City of Surrey
PLANNING & DEVELOPMENT REPORT

File: 7911-0228-00

Planning Report Date: May 7, 2012

in order to permit the development of 198 apartment units within three buildings.

project title:	-VERVE- RESIDENTIAL DEVELOPMENT 13913 FRASER HWY SURREY, BC
drawing title:	BUILDING -A- WEST & SOUTH ELEVATIONS
project no.:	11015
drawn by:	ST
checked by:	TR
date:	FEB. 2 2017
scale:	1/200

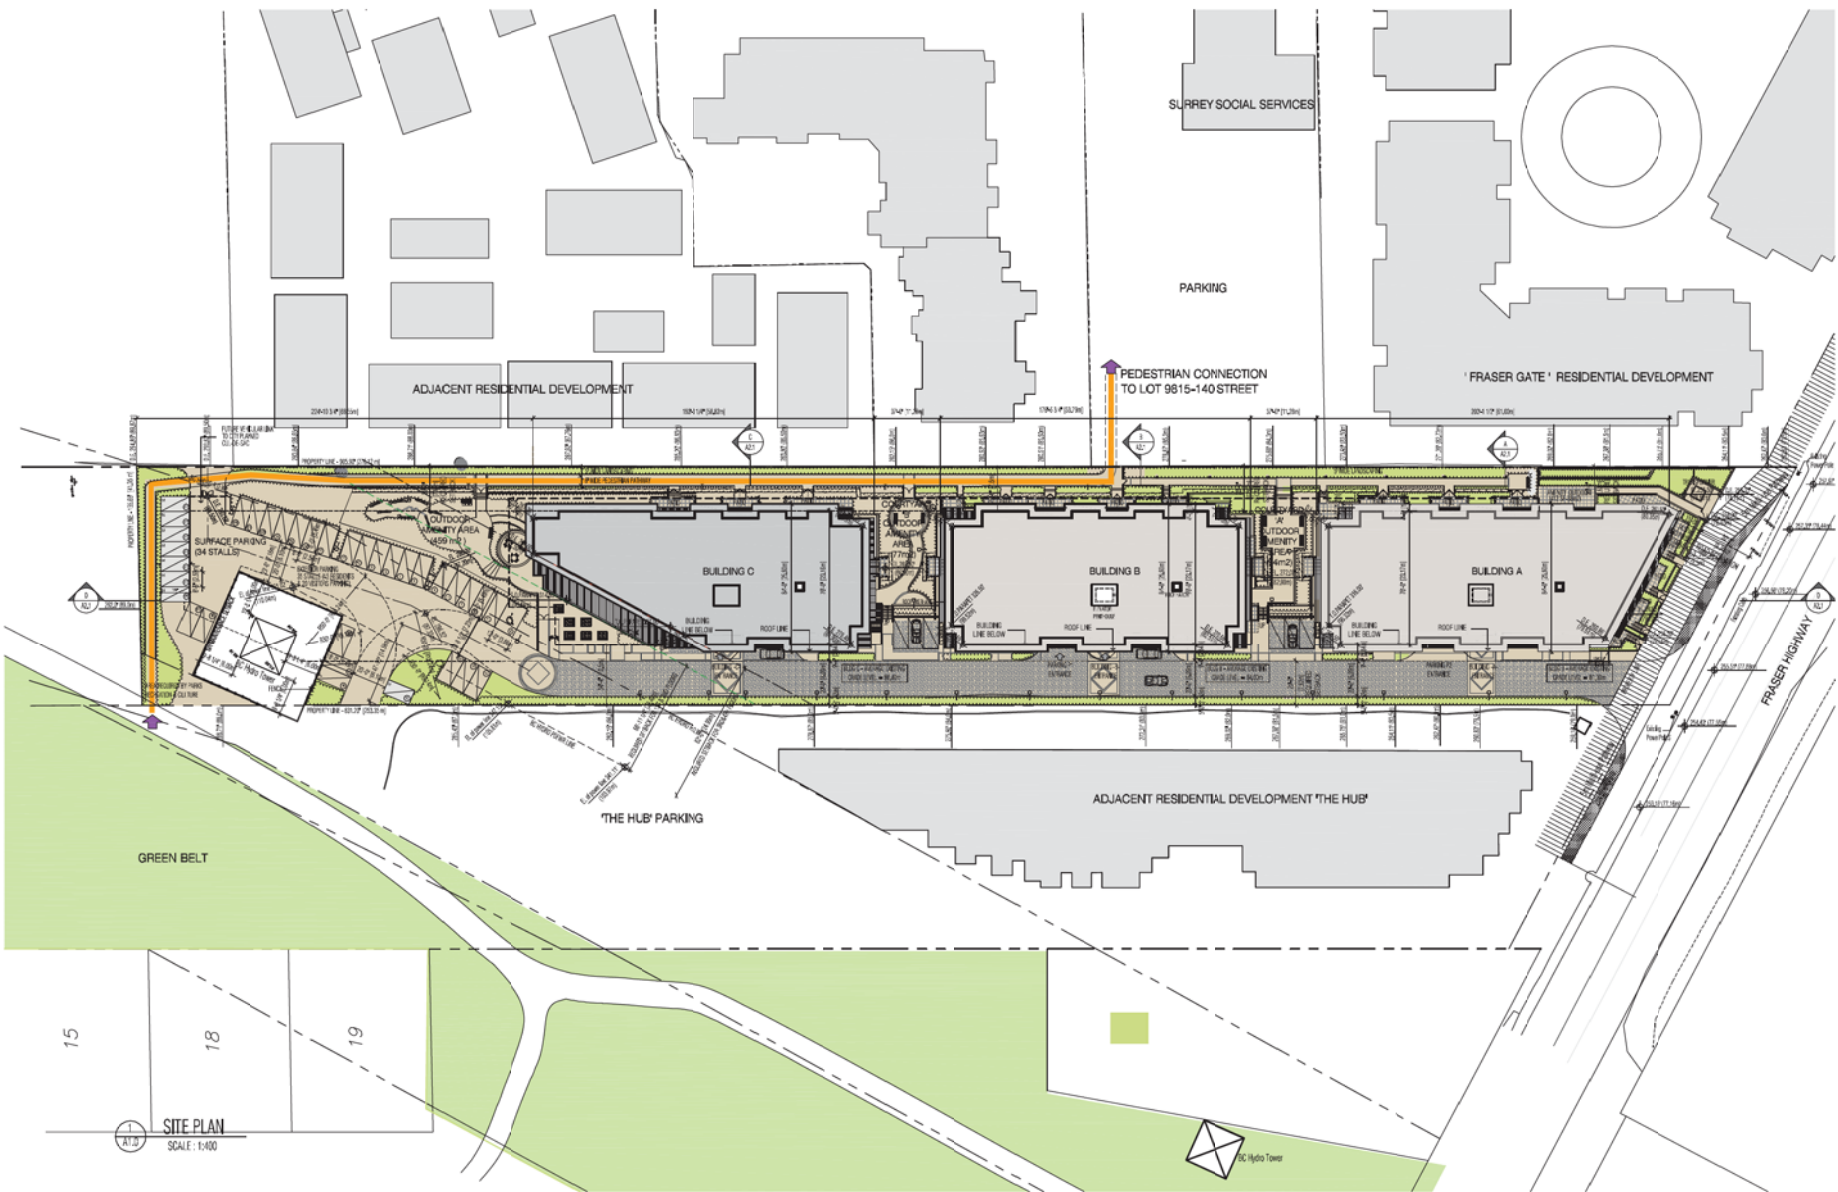
- Opportunity to provide sun shading devices that can contribute to the playful nature of the design.
- Should consider eyebrows for the south facing windows to take some of the pressure off solar gain.

On the south elevation, the top floor of proposed Building A has been set back and a large overhang has been added to the floor below which will help to provide shade. Ground level columnar deciduous trees will shade the elevation in summer.
